TRANSMITTAL NO. 81

SECTION 15400 - PARAGRAPH 2.4.1

UNACCOMPANIED ENLISTED PERSONNEL HOUSING  
MARINE CORPS BASE, CAMP LEJEUNE, NC

DEVIATION FOR WATER CLOSETS

ANGLESEY K-4486-ET / K-4498-ER

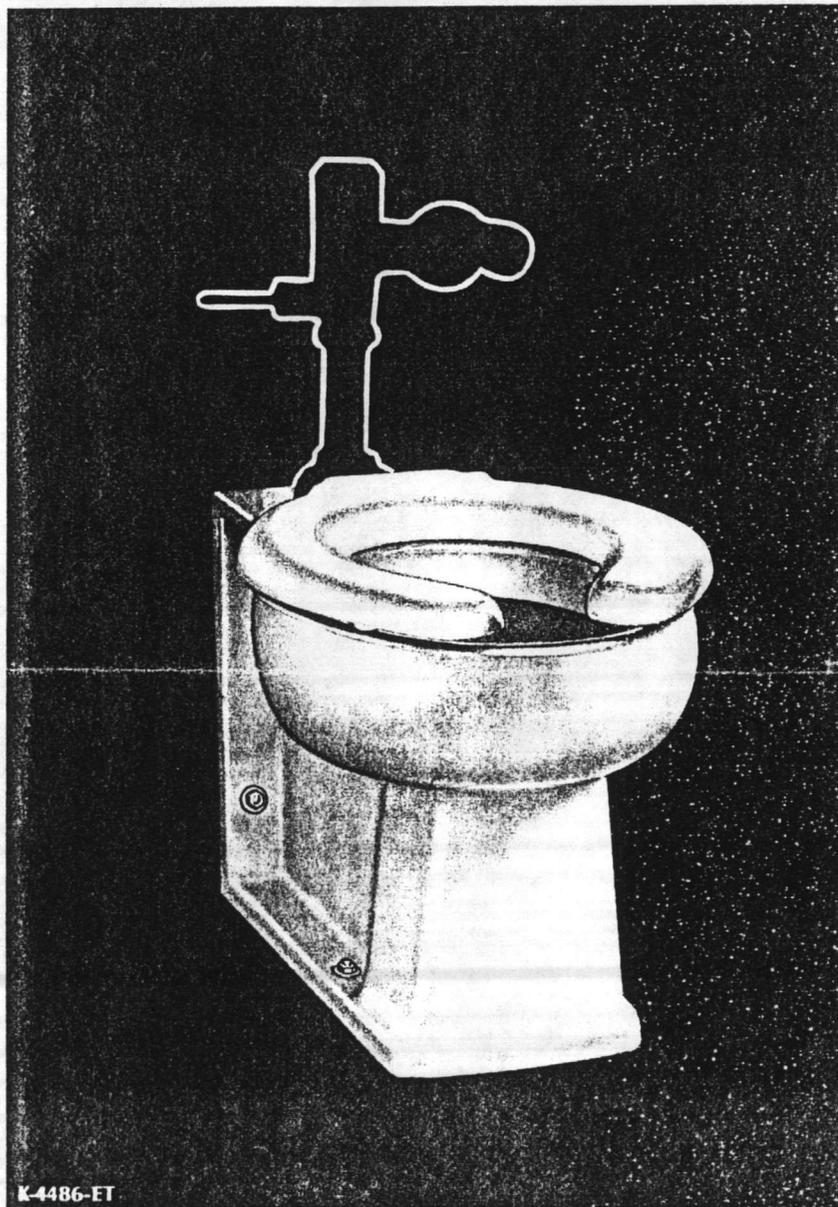
DEVIATION: APPROVED

In reference to the above mentioned water-closet as submitted for this project, it has come to my attention that this closet, K-4486-ET, requires between 4½ and 5 gallons per flushing cycle to properly cleanse.

Neither myself or Kohler company are aware of any fixture manufacturer who offers a floor mounted, back outlet flush valve type closet bowl which operates on 4 gallons as requested.
